ULNRC-3050

DOCKET NUMBER 50-483
CALLAWAY PLANT
CONTAINMENT SPRAY ADDITIVE SYSTEM RETIREMENT
Reference: ULNRC-3023 dated May 20, 1994

This amendment application replaces Technical Specification 3/4.6.2.2, Spray Additive System, with a new Specification 3/4.6.2.2 entitled Recirculation Fluid pH Control (RFPC) System. The current Spray Additive System will be retired, pending approval of this amendment request, and replaced with the passive RFPC System consisting of stainless steel baskets containing trisodium phosphate dodecahydrate (TSP-C). One such basket will be located within the confines of each containment recirculation sump and will contain sufficient TSP-C to ensure a minimum equilibrium sump pH of 7.1. The new LCO will ensure that the amount of TSP-C contained in the baskets is greater than this minimum amount yet less than the basket design capacity. Mode Applicability and the Action Statement for the new specification are unchanged from the current specification while the Surveillance Requirements have been revised to correspond to the passive nature of the RFPC System. The Bases for 3/4.6.2.2 have been revised accordingly as have the Bases for 3/4.5.5, RWST. A similar c

CONTAINMENT SPRAY SYSTEM
(M-22ENORQ)-2)

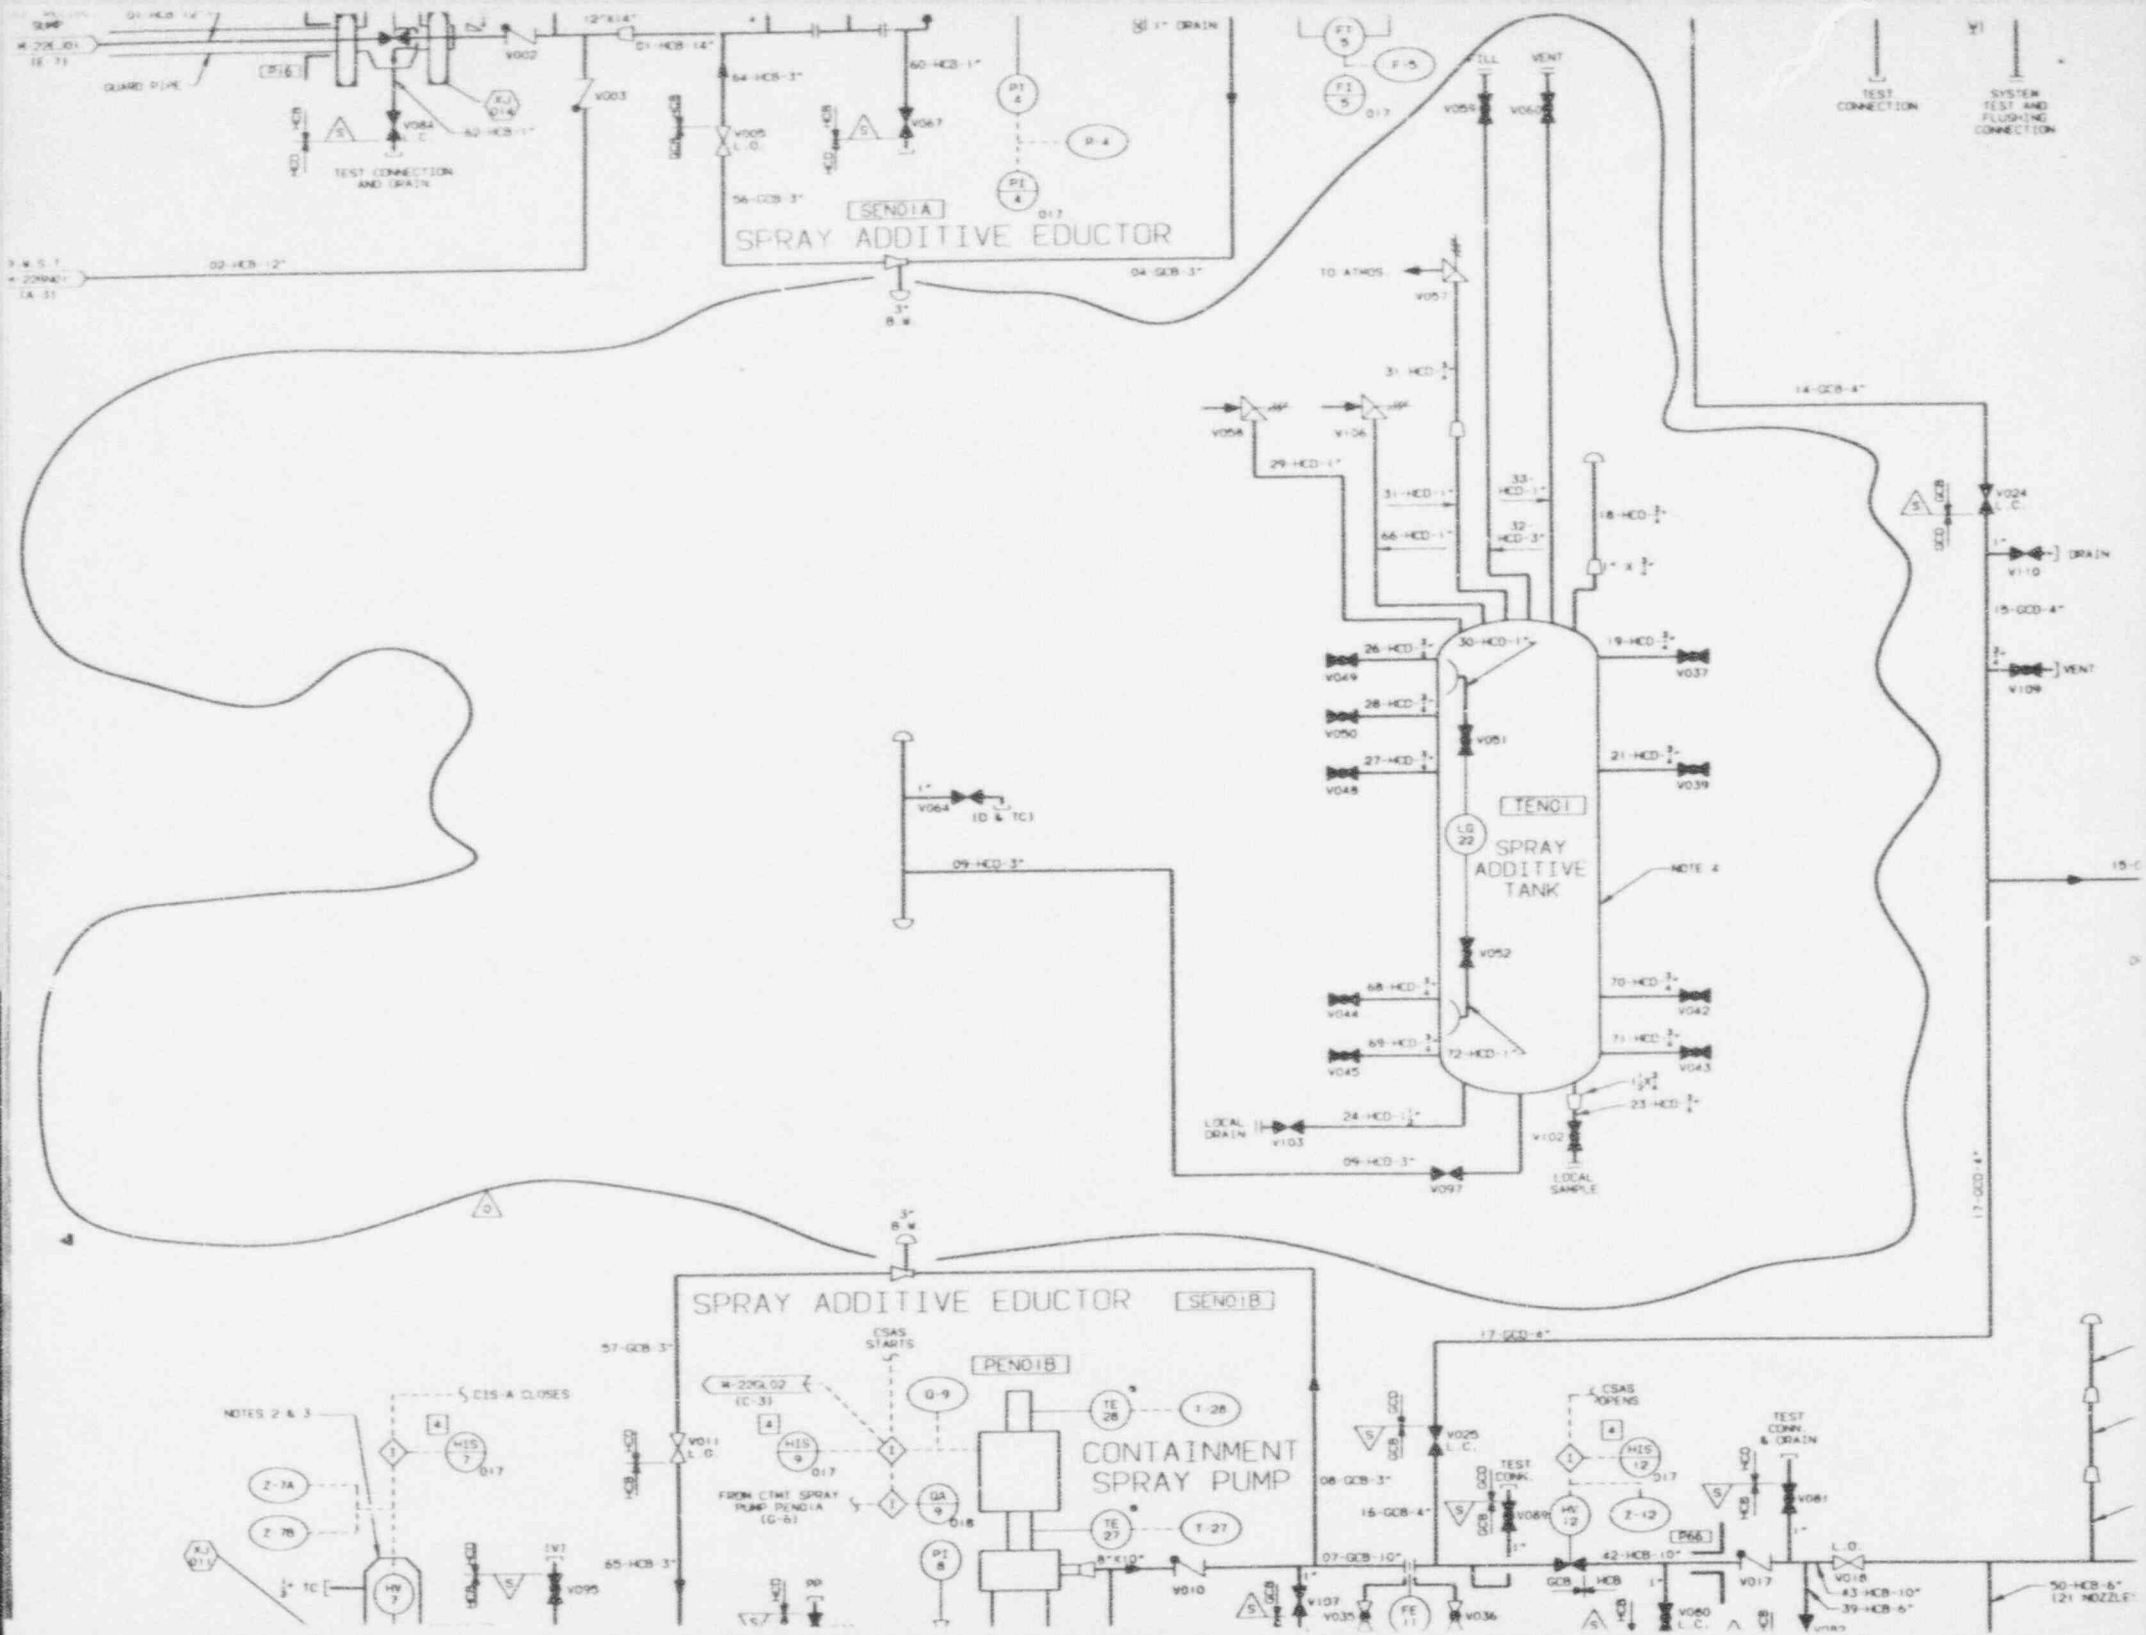
Four floor mounted plates will be anchored (using Hilti Kwik Bolt II anchors) within each sump to support carbon steel beams which will support the baskets. Piping, valves, and flow instrumentation from the spray additive eductors to the common line from the spray additive tank will be removed and the lines will be capped. The spray additive tank will be retired in place and its level and pressure instrumentation will be removed. These changes are shown on the mark-up of FSAR Figure 6.2.2-1 in Attachment 5. The instrumentation,

including all annunciators and associated wiring, will be removed from the system and from the main control board.

III. Sprayed Fluid - Recirculation Phase

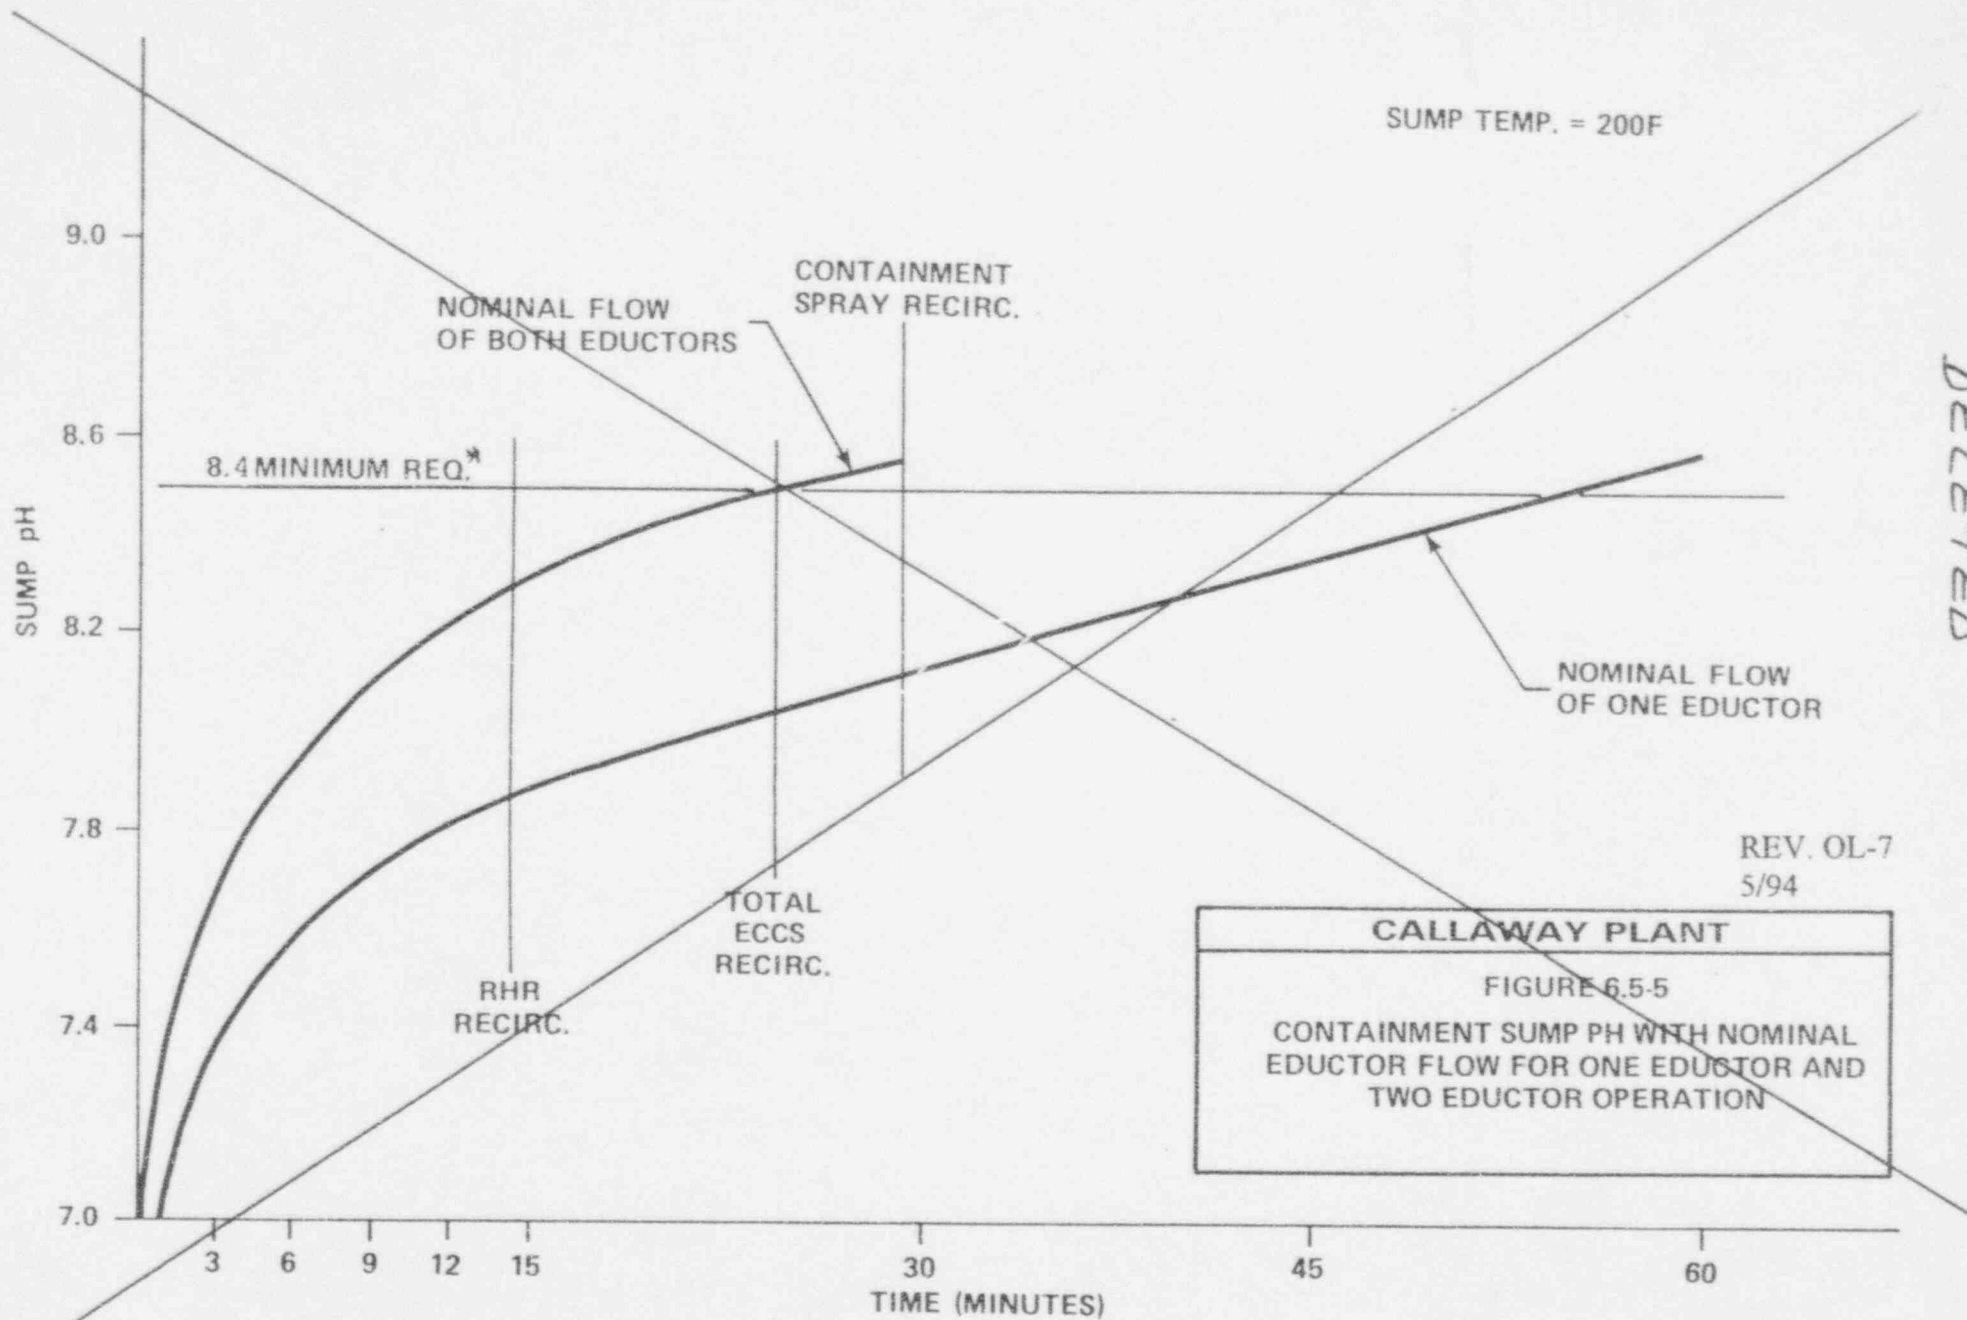
~~4.0-11.0~~ ^{-7.0}
 100
 100
 2,500/2,350
~~0-7,530~~
 37-120

~~8.0-11.0~~ 7.1-11.0
 2,500/1,900 2,007
~~10,300~~
 120-255
